Access Compliance Report

Public Rights-of-Way

Intersection ID: 17202	Main Street: S I-77 EXIT 6B RA	Cross Street: S TRYON ST	Location: SW
ADA ID: 4ADDE49105CC	Ramp Type: Perp	Initial Pass/Fail: Pass	Overall Compliance: No
		Severity Score: 0

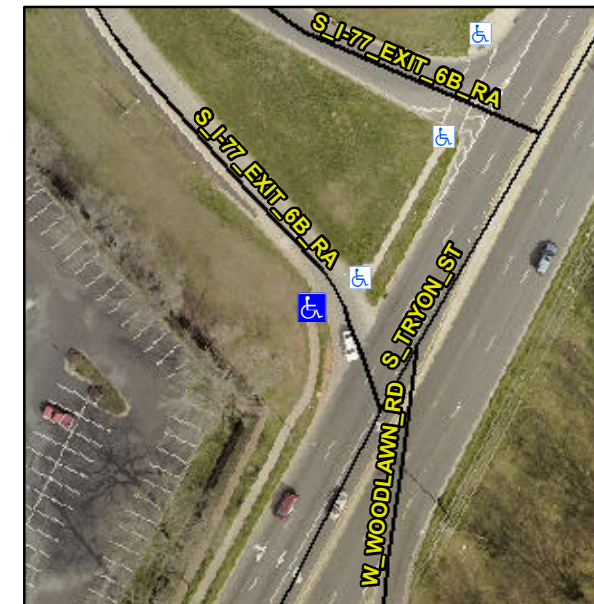
Remove & Replace Detectable Warning System.

R305.2
